APPLICATION FOR BUILDING PERMIT

Existing window in primary bathroom being replaced as part of existing building permit #BP2021-0145.

Lamsvelt/ Thompson Residence
Building Permit No. BP2021-0145 (16 Park Road, Irvington NY)
Parcel No. 2.100-56-15 (06 13B00000 P5A2)

Lamsvelt Thompson
Residence
Phase I
16 Park Road
Irvington, NY

A-0.10

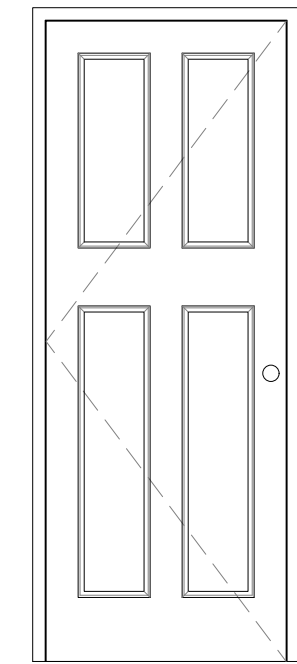
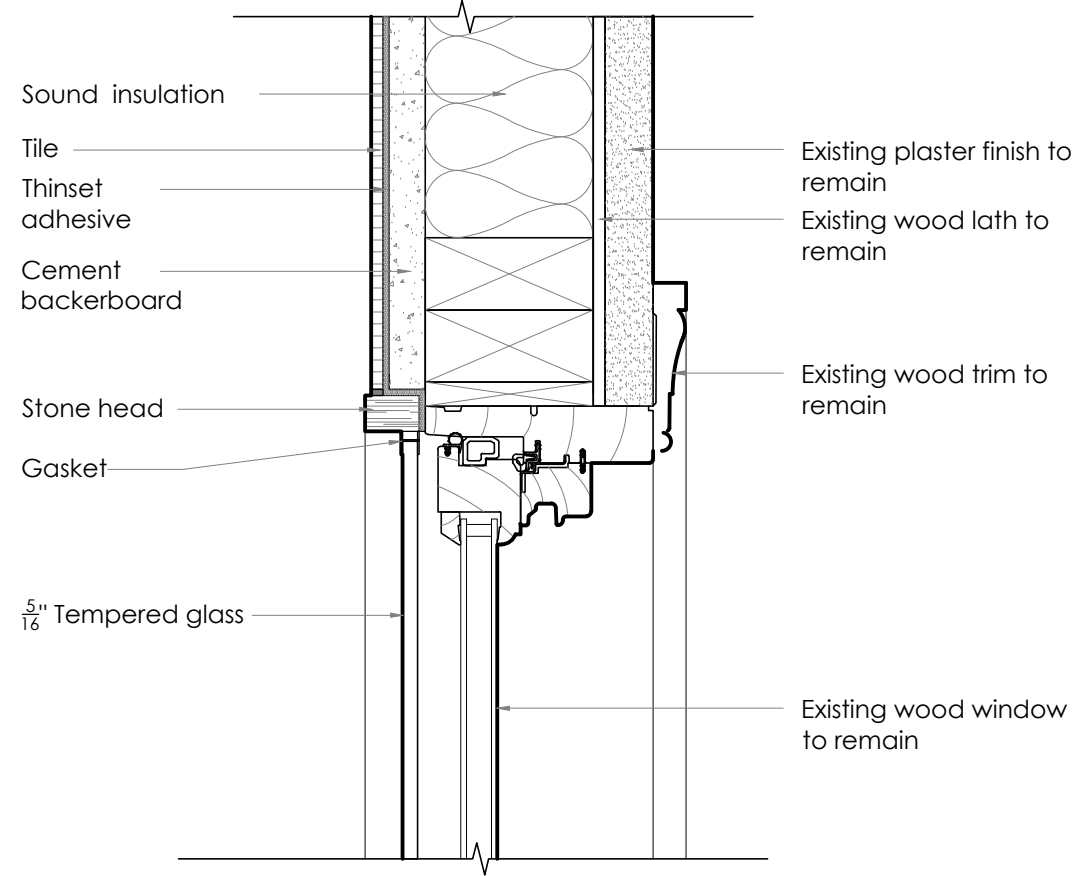
- Sheet A-0.10 Door and Window Schedules:
 - New sheet
 - Exterior window in Primary Bath is to be replaced – Refer to schedule for window specification.

Window Schedule							
Type	Description	Manufacturer	Product No.	Rough Opening	Material	Finish	Remark
A1	Ultimate Wood Casement Pushout	Marvin	Custom	43" x 58 1/2"	Aluminum / Wood	Bronze Ext. / White Primed Int.	Tempered glass. Provide casement in-swing screen. G.C. to verify existing unit dimensions.

1 Window Head @ Primary Bathroom Shower

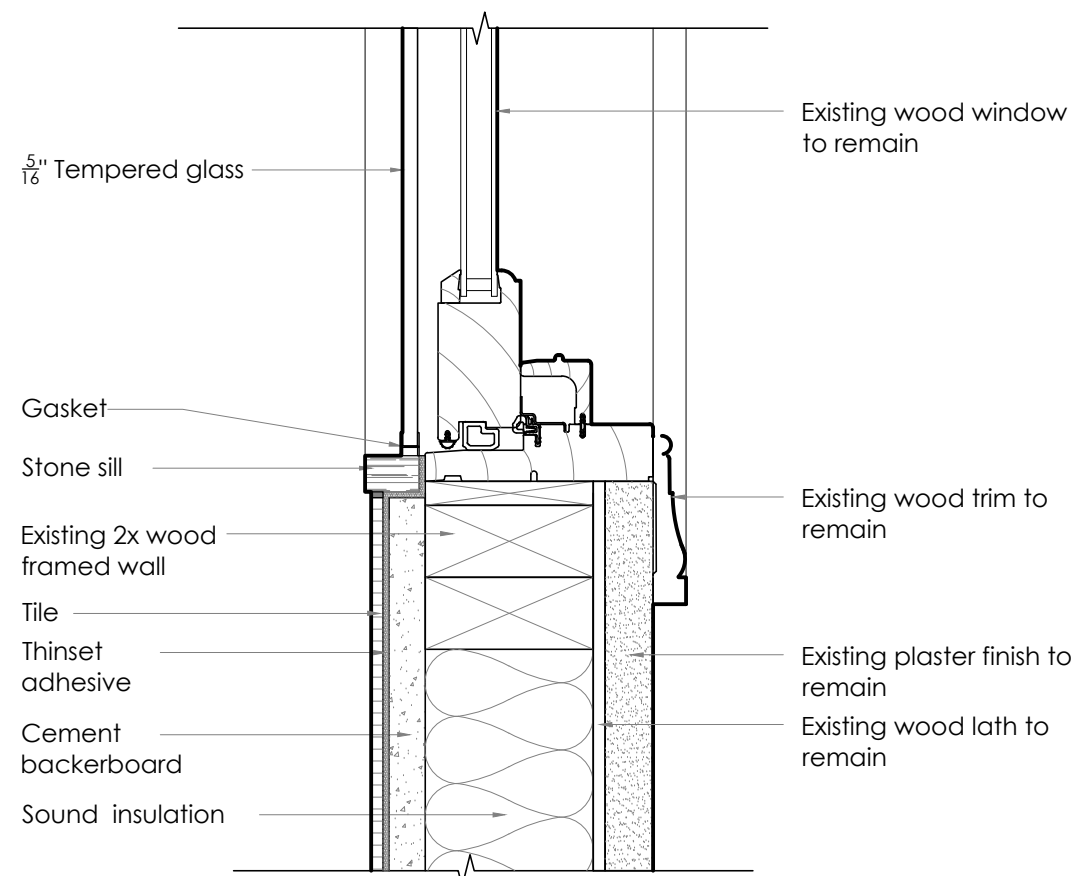
- Sheet A-1.00 Demolition and Proposed Floor Plans:
 - A note has been revised to indicate the change of insulation from comfort batt mineral wool.
 - Finish schedule has been added.
 - Tempered glass has been added to window in shower.
 - Exterior window on Primary Bath is to be replaced. Refer to note and
- Sheet A-1.01 Reflected Ceiling and Electrical Plans:
 - Lighting has been revised on the second-floor primary bathroom.
- Sheet A-2.00 Enlarged Plans and Interiors:
 - Vanities in Primary bath and Powder Room revised.
 - Plumbing and Accessory Schedules has been updated.
- Sheet A-2.10 Interior Details
 - Tile floor detail has been added.
